PLANNING AND ZONING COMMISSION AGENDA-REGULAR MEETING

Monday, June 11, 2018

STAFF REPORT
KETCHUM PLANNING AND ZONING COMMISSION
REGULAR MEETING OF JUNE 11, 2018

STAFF REPORT
KETCHUM PLANNING AND ZONING COMMISSION
REGULAR MEETING OF JUNE 11, 2018

Attachment B.
Preliminary Plat dated June 5, 2018

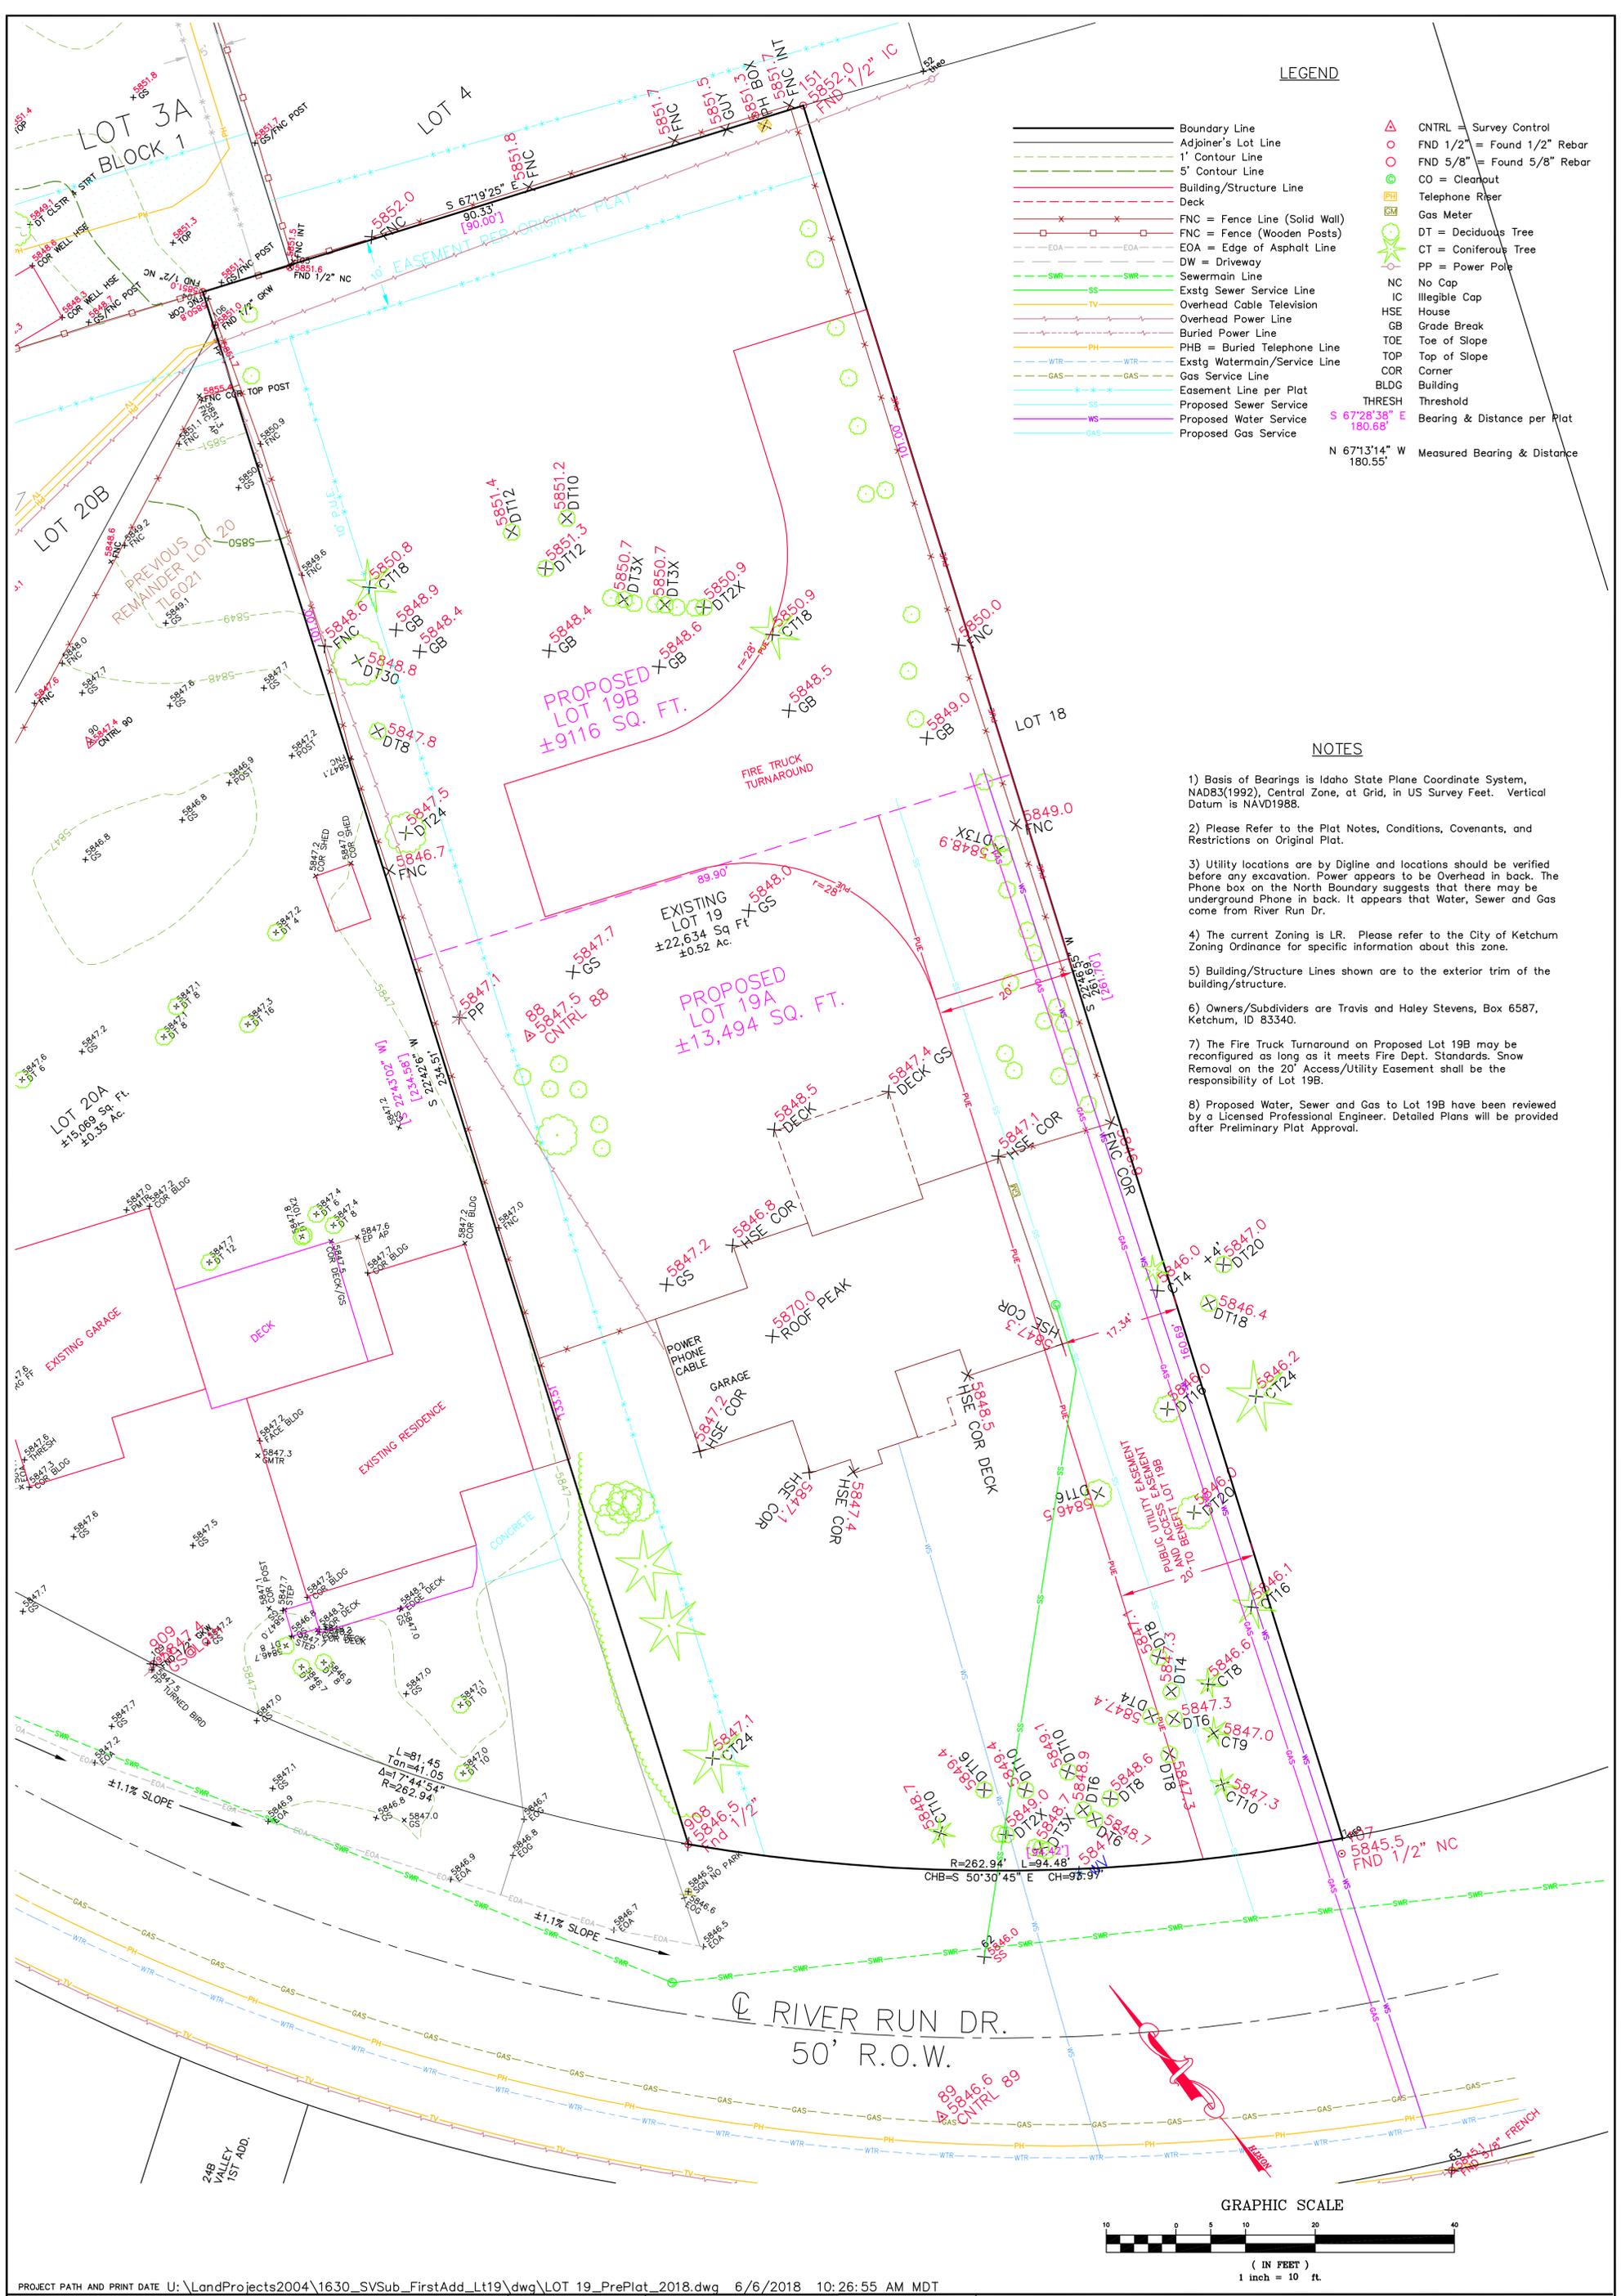
I live immediately across the street from 314 River Run Drive. I would like to see the proposed plat for lots 19A and 19B. What I am most concerned with is the inclusion and maintenance of a proper "public right of way". River Run Drive is notorious for property owner who have landscaped into the "public right of way", thereby creating dangerous conditions for pedestrians and motorists on this blind u shaped street. It is my belief that the "public right of way" is a 25 foot strip of land between the "lane of travel" and the landscaping or dwelling. Am I correct on this? Please respond to my comments. Thank you, Kathleen Phelan

With reference to the proposed Stevens subdivision I would like to recommend that the existing "Public Right of Way" be corrected at this time. Currently it is completely landscaped thereby preventing cars from legally parking in front of the residence. River Run Drive is a horseshoe shaped street with most of the residences landscaped into the "public right of way" creating dangerous "blind" conditions for pedestrians and vehicles. Since this will be a new subdivision it seems to me to be the appropriate time to correct the "public right of way".
